## STAFF RECOMMENDATION 121 Blackburn Avenue November 18, 2015

**Application:** New construction – addition with setback determination; Partial demolition

**Description of Project:** This application is for construction of a rear addition to the home with a side setback determination of three feet (3').

Proposed Site Plan

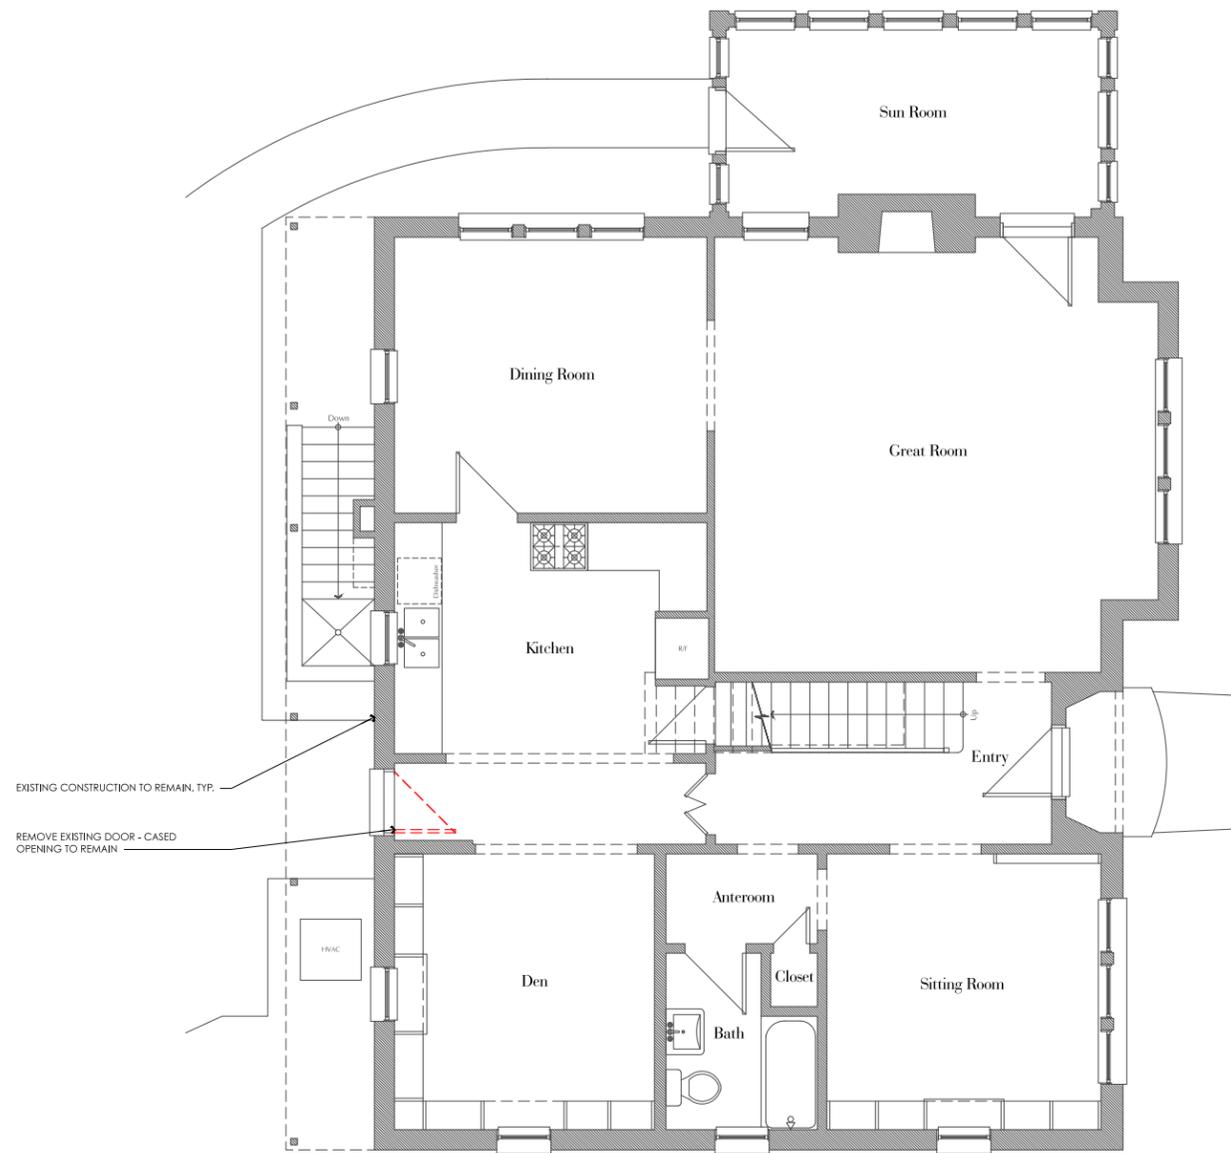
Setback: The setbacks will be three feet (3') on the left side, and thirty feet (30') on the right side. The rear wall of the addition will be forty-five feet (45') from the rear property line. The minimum side setback per the Zoning Code is five feet (5'), and the applicant has requested a setback determination of three feet (3') for the left side setback. The left side wall of the existing historic house appears to be situated on the property line. Staff finds that the requested three feet (3') setback is appropriate given the location of the historic house and recommends approval of the requested setback determination. The project meets section II.B.i.c for setbacks.

Proposed Main Floor Demolition Plan

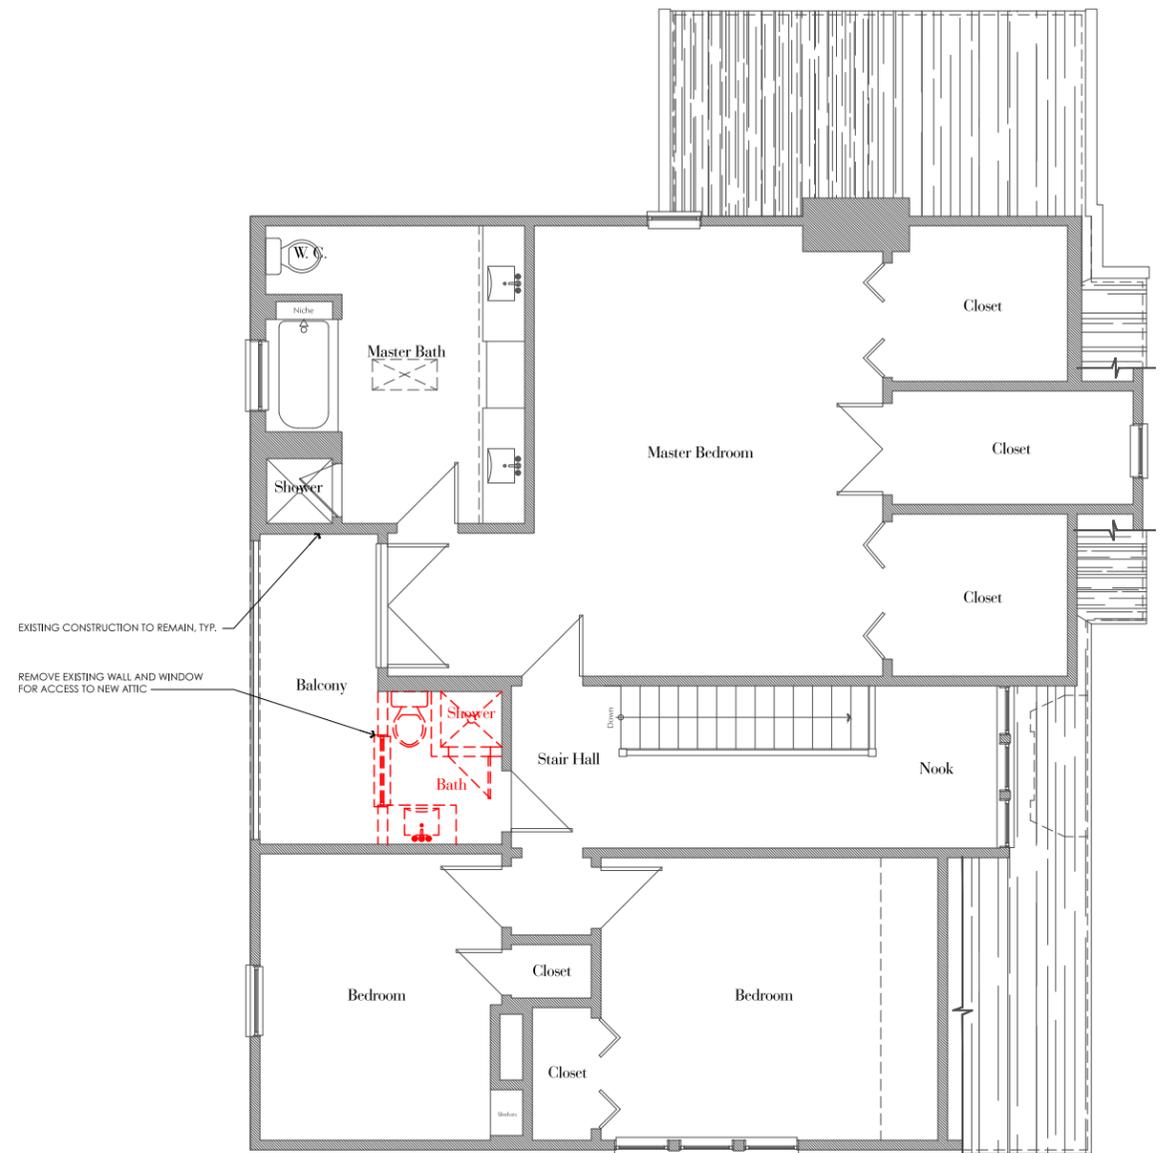
Demolition: Demolition is proposed for a small portion of the rear wall on the upper story of the house. However, the plan proposes to keep the rear corners intact. The plan does not include any demolition of the rear wall on the main floor. An existing opening will provide access to the proposed addition. No changes to the dimension and design of the existing openings are proposed. Staff finds the proposed demolition meets Section III.B.2 for appropriate demolition and does not meet section III.B.1 for inappropriate demolition.
